AGENDA ITEM #19A
July 28, 2009

MEMORANDUM

SUBJECT: Germantown Sector Plan

SUBJECT: **Worksession**—Germantown Employment Area Sector Plan—transportation elements

**Aircraft Drive/Crystal Rock Drive
One Way Circulation**

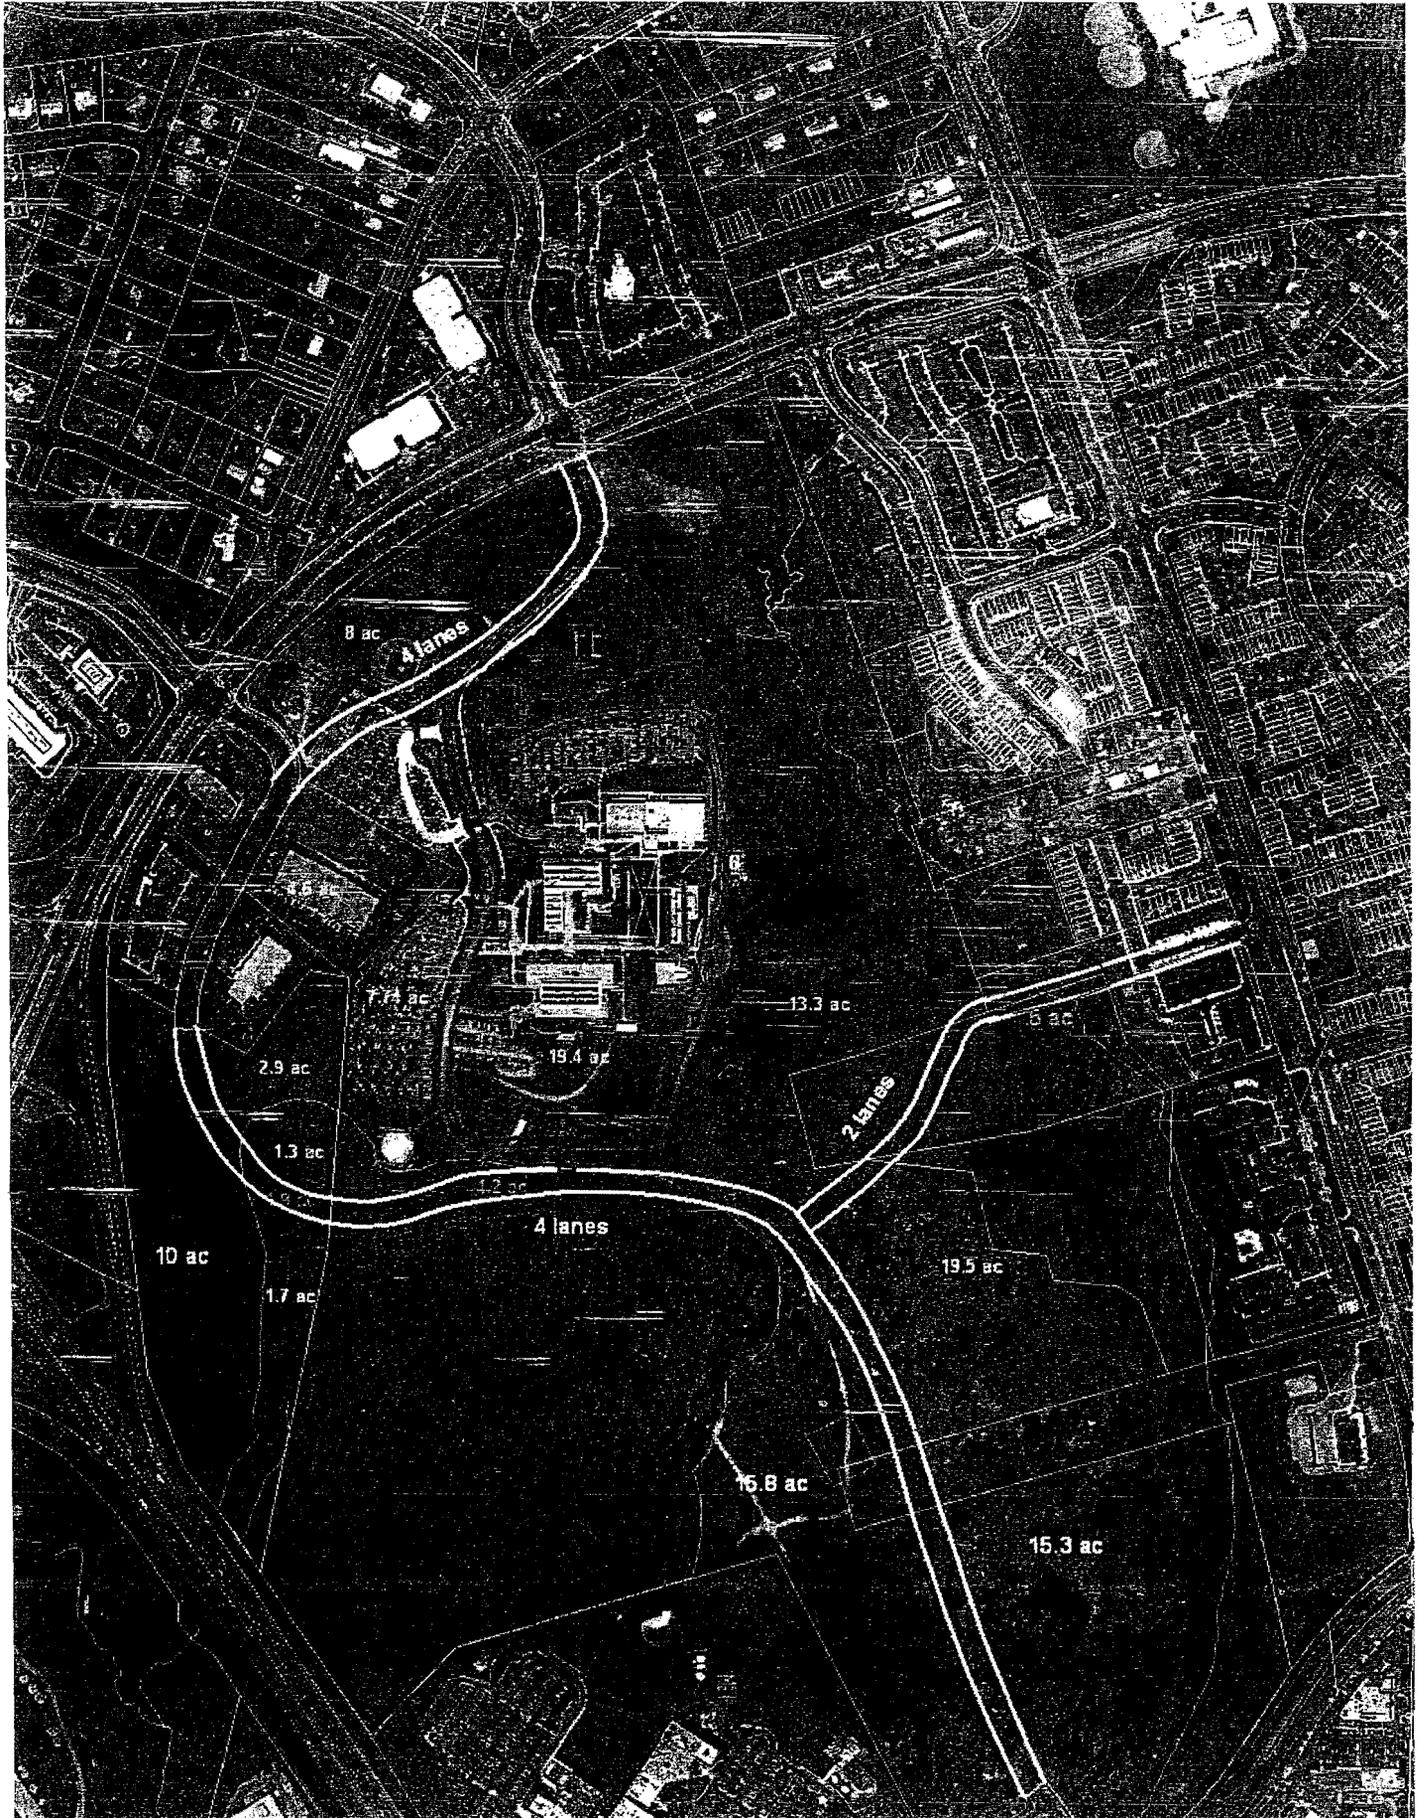
6. Aircraft/Crystal Rock one-way pair. The Sector Plan recommends evaluating converting Aircraft Drive and Crystal Rock Drive as a one-way pair through the Town Center area, with Aircraft Drive headed southbound and Crystal Rock Drive northbound (©26). DOT opposes any operational recommendation in a master plan, and it believes that this suggestion may negatively affect the fire and police stations there.

Planning staff's response is that access to and from the police station would be accommodated via driveway access on both Aircraft Drive and Crystal Rock Drive, eliminating the need to circulate around the block. Fire trucks could exit the station on to Crystal Rock Drive, as they do now, and could turn right to head west up Crystal Rock Drive or turn at

PHED Committee (and Council staff) recommendation (3-0): Concur with the Sector Plan. Council staff agrees the recommendations about traffic operations are generally not appropriate in master plans, but in this instance the Sector Plan is only suggesting that the one-way pair must be *evaluated*. There is sufficient rationale to give this matter serious consideration.

Option 2

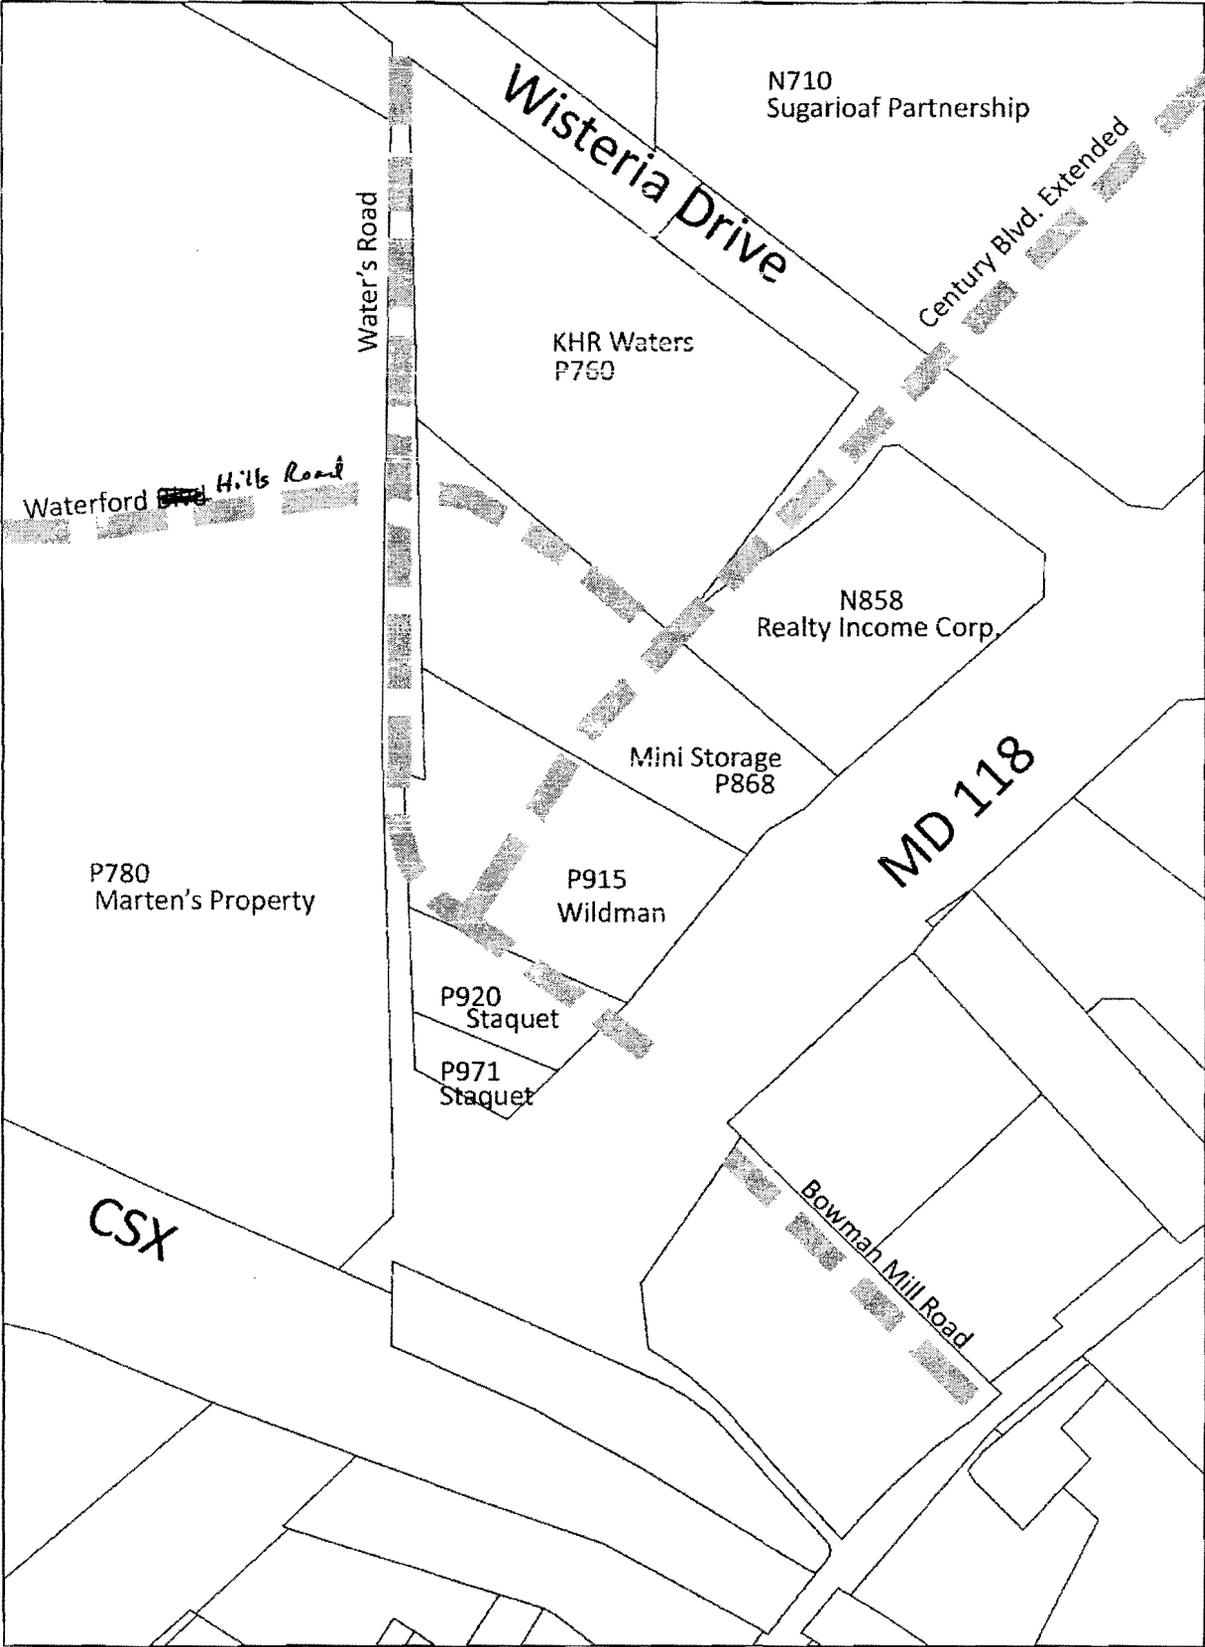
Option 2 is a plausible alternative to the Sector Plan's proposed access (©32). There is an existing median break and left turn bays at MD 355; all that appears to be missing is a set of traffic signals and some signing and marking. However, a new two-lane roadway would have to be built to the west that would take property from the Oak Mill Apartments, including some of its northernmost parking lot. Since the land west of the apartments is in the stream valley, there appears to be no location to replace the lost parking. A question is whether the complex could reduce the number of its parking spaces (which includes several visitor spaces) yet stay within Code requirements.

PHED Committee recommendation (3-0): Concur with the Sector Plan's recommendation for the Cider Press Place connection, but add a note stating that an alternative equivalent route may be selected. Council staff recommends accomplishing this by adding the following footnote to the Cider Press Place description on page 67 of the Sector Plan:

West End Proposed Street Network

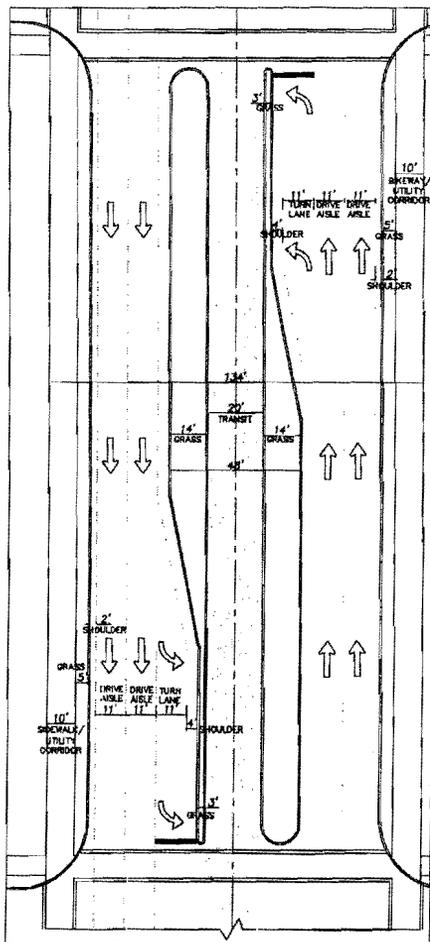
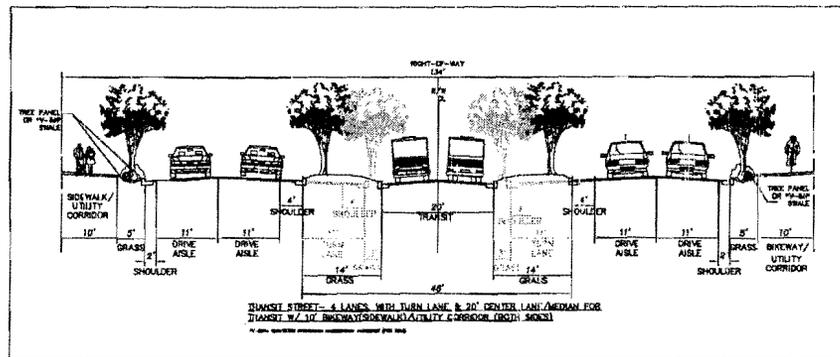
Robert Brewer, representing Trammel Crow, recommends a 134'-wide right-of-way for this section of Century Boulevard. He transmitted a typical plan view and cross-section showing how 134' could accommodate four travel lanes (each 11' wide) with a 4'-wide offset to the inside curb and a 2'-wide offset to the outside curb, 14'-wide planting strips between the CCT and the roadways and 5'-wide strips between the roadways and the sidewalk or bike path (©34).

PHED Committee (and Council staff) recommendation (3-0): Set the minimum right-of-way at 134'. The curb offsets in ©34 are too generous (1' to either the inside or outside curb is sufficient, requiring 8' less) and that the CCT width is too narrow (it should be 6' more: 26', not 20'), and that the planting strip between the CCT and each roadway should be 15' not 14' (requiring 2' more). This would provide the 56' required by MTA within a 134' right-of-way. Also recall that rights-of-way designated in master and sector plans are *minimums*: the Planning Board can require a wider right-of-way in spots where ancillary facilities are necessary: turning lanes, stormwater management facilities, etc.

CRYSTAL ROCK
 Development Masterplan

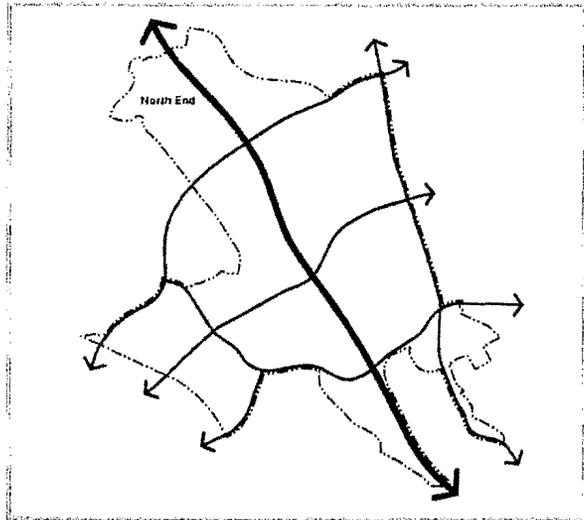
13. Crystal Rock Drive alignment in North End District. The Sector Plan shows the north end of existing Crystal Rock Drive to be extended as a Business District Street (B-11) and looped around to meet Century Boulevard at the new Dorsey Mill Road, near the proposed Manekin CCT station. The Lerner Corporation, which owns much of the property through which this road would traverse, wishes to have the Sector Plan show B-11 not as a loop but as two roads intersecting at a traffic circle. (See the Rodgers Associates memorandum on ©35, Lerner’s proposed development concept on ©36, and Sector Plan’s loop geometry is on ©37-38.)

The Sector Plan’s diagrams merely mean that the end of Crystal Rock Drive and Century Boulevard should be connected by a Business District Street, thus what the Lerner Corporation is proposing is consistent with the Sector Plan. It is common for a master plan to propose a connection, with the ultimate shape of that connection to be determined at preliminary plan or site plan approval. An example: the Kensington/Wheaton Master Plan (1990) proposed a future primary residential street connection through the Indian Spring Country Club between Georgia Avenue and Layhill Road via Tivoli Lake Boulevard and the Indian Spring Access Road. The plan showed a looping alignment (see P-13 on ©39). However, when the preliminary plan was approved 18 years later, it showed that the extension of these two roads met at a town square (©40): the primary residential street connection was made, but at a town square requiring right-angled turns, not dissimilar to what the Lerner Corporation proposes.

PHED Committee (and Council staff) recommendation (3-0): Retain the current diagrams in the plan. Identifying the specific alignment on ©36 in the plan presupposes that that particular development concept will be approved. Before all is said and done, what if the Lerner Corporation decides to proceed with a somewhat different concept? What if it ultimately decides to sell its interest to another developer, which may have a different concept? Rather than

locking in an alignment now, the alignment in the plan should be as generic as possible. However, should the Lerner Corporation ultimately proceed with the concept through plan approval, **it would help if the Council were to provide supportive legislative history by indicating for the minutes that the alignment on ©36 is consistent with the Sector Plan.**
